ADDENDUM NUMBER 2

Re: North Brunswick High School HVAC
South Brunswick High School HVAC
West Brunswick High School HVAC
Brunswick County Schools
Proj. Number: PC21P0006

MDI Proj. No.: 213763

SHEET NUMBER
M101A

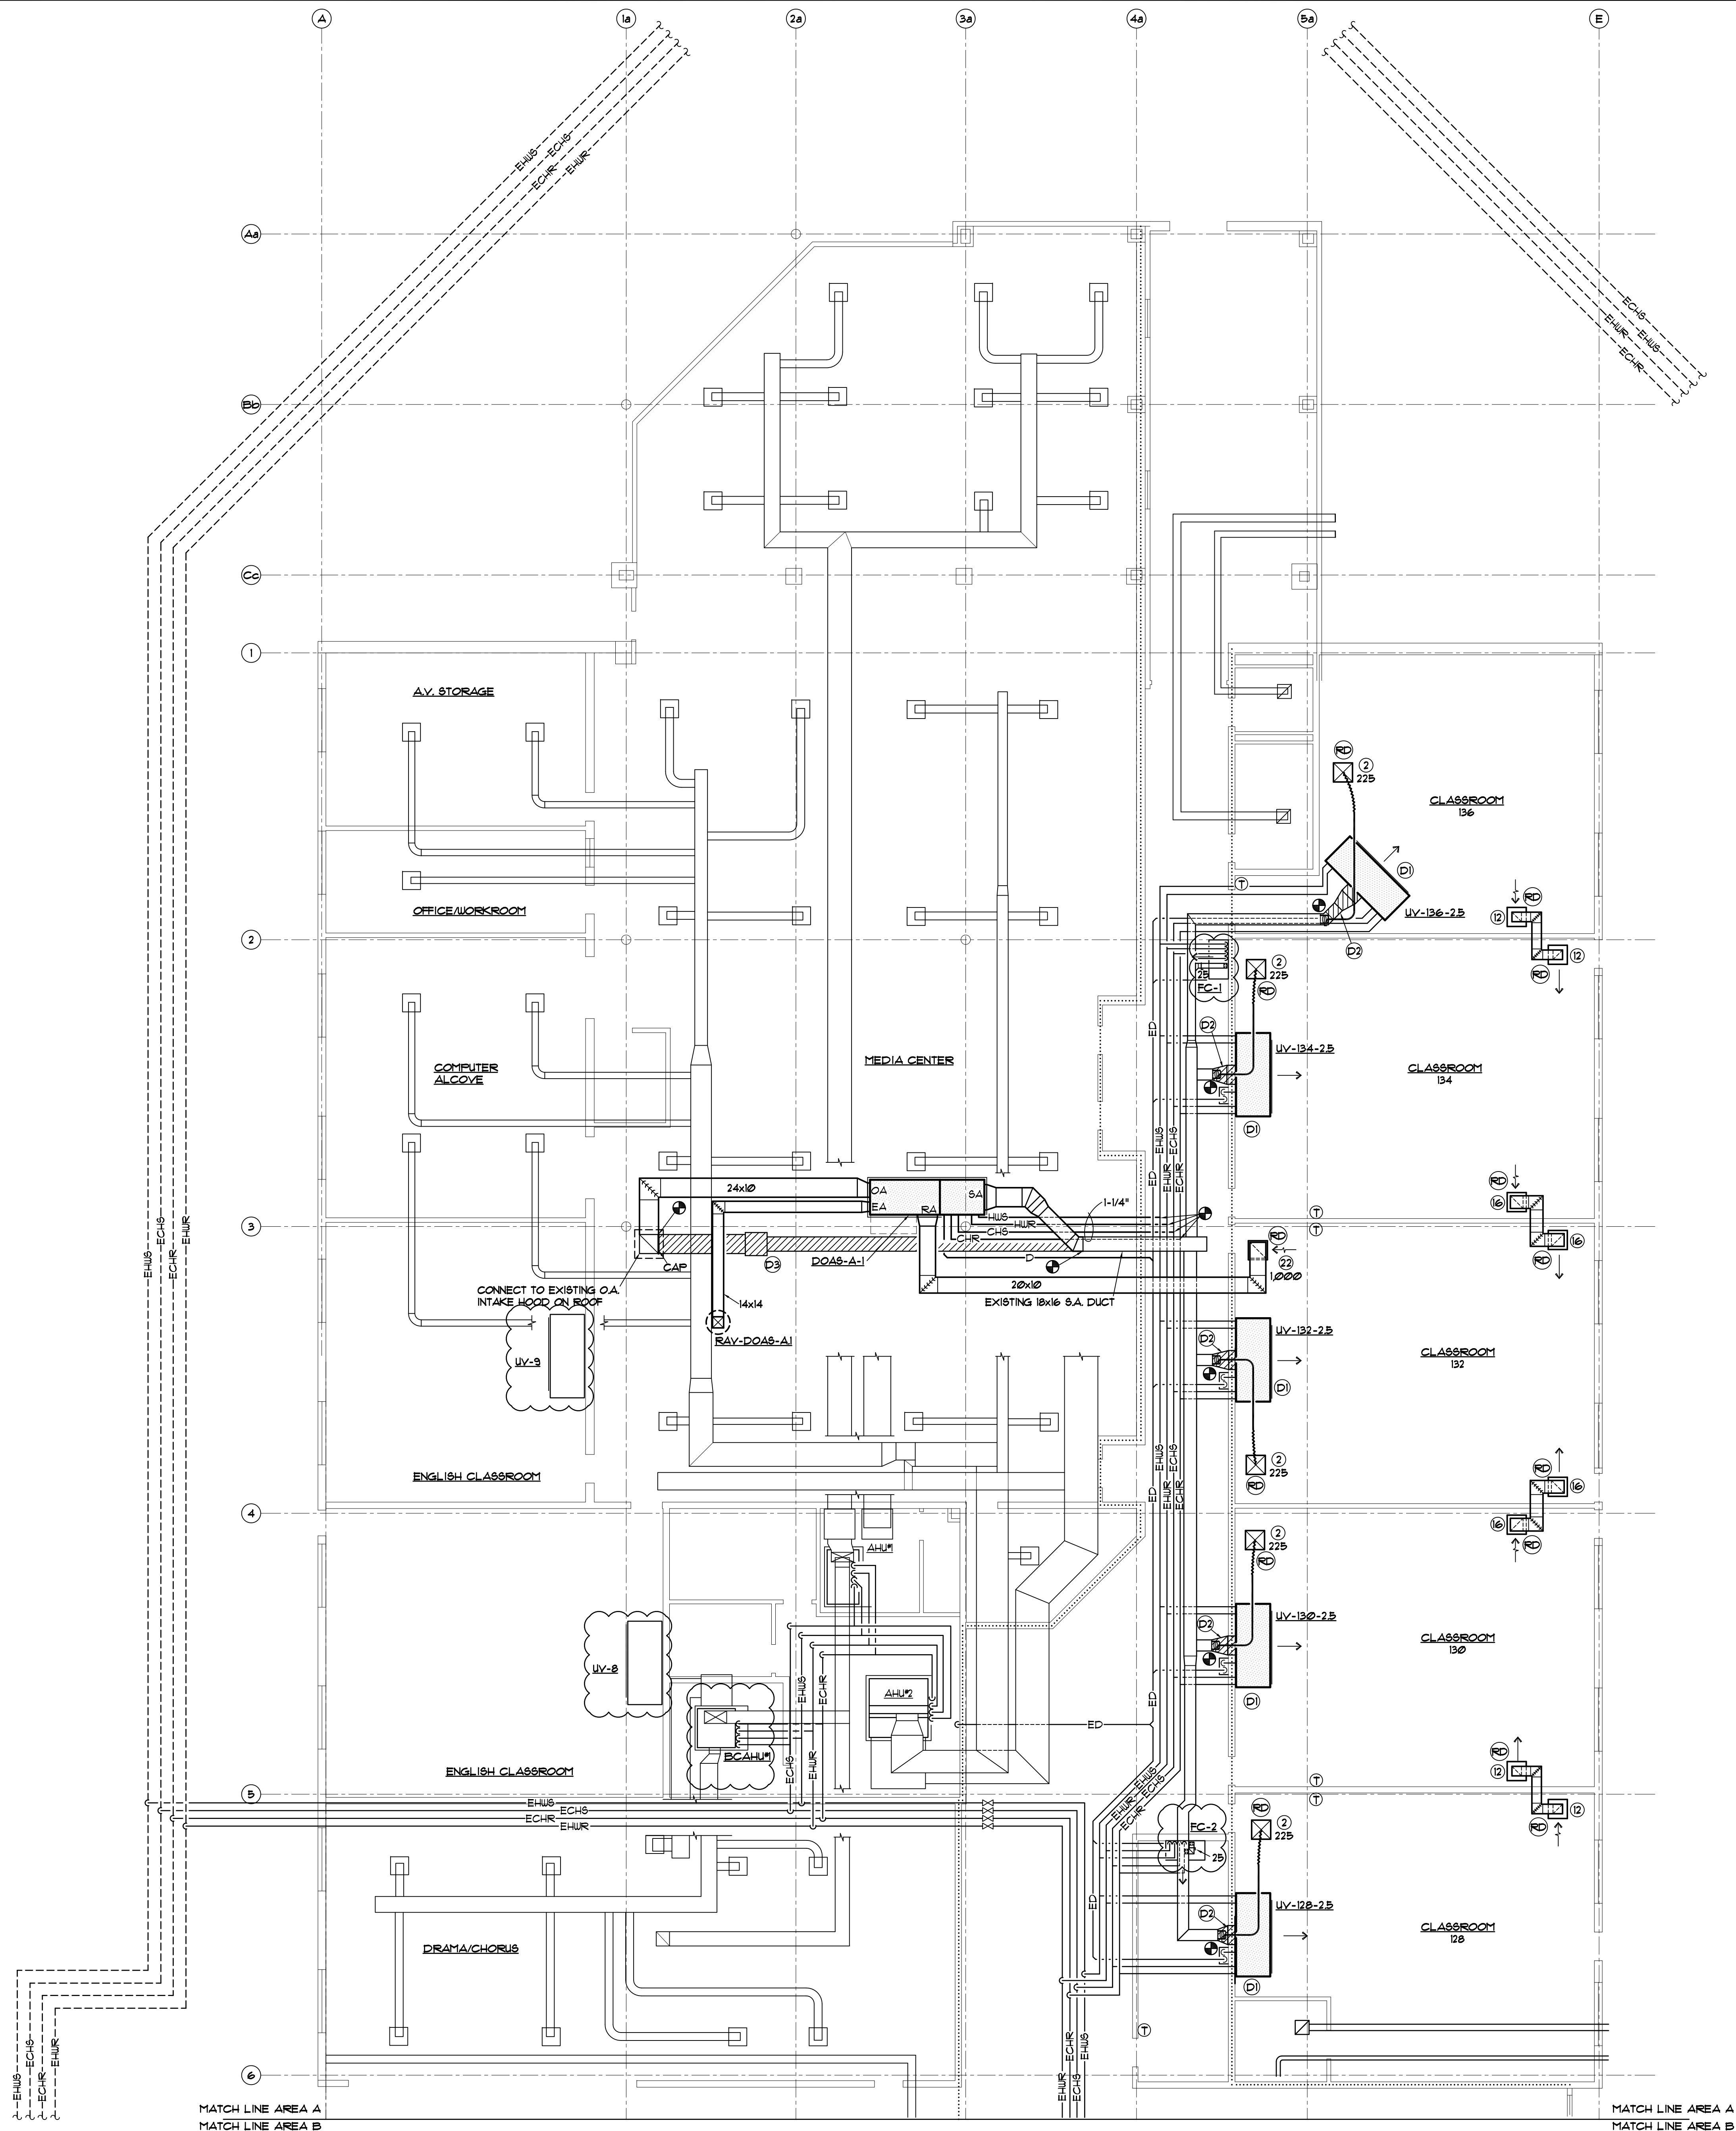
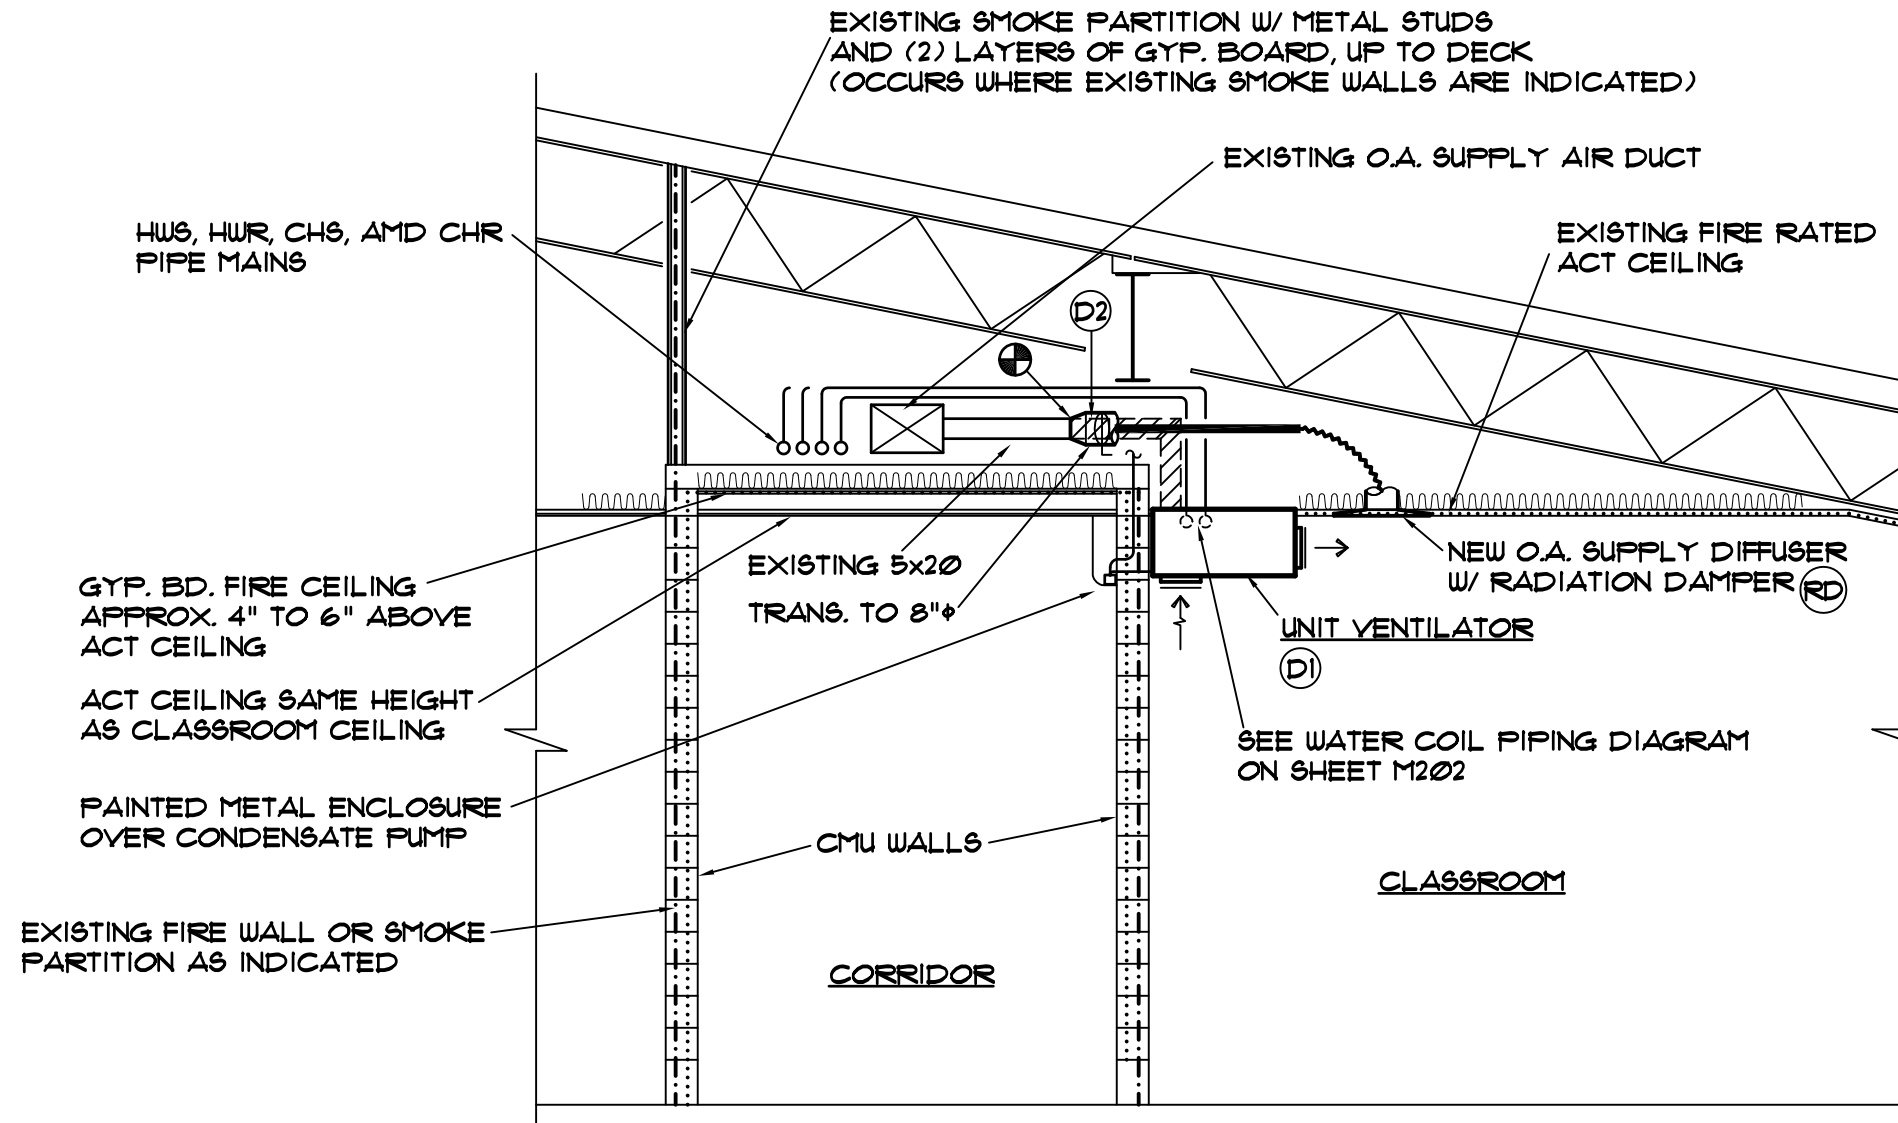
1. Refer to drawing M001A Control Valve Schedules for all (3) high schools
2. Refer to North Brunswick High School drawings M101A (Area "A") and M102A (Area "B"). Remove existing control valves complete, and replace with new control valves furnished by automatic temperature controls company as noted on the Control Valve Replacement Schedule on M001A. Applicable equipment on these (2) drawings are clouded.
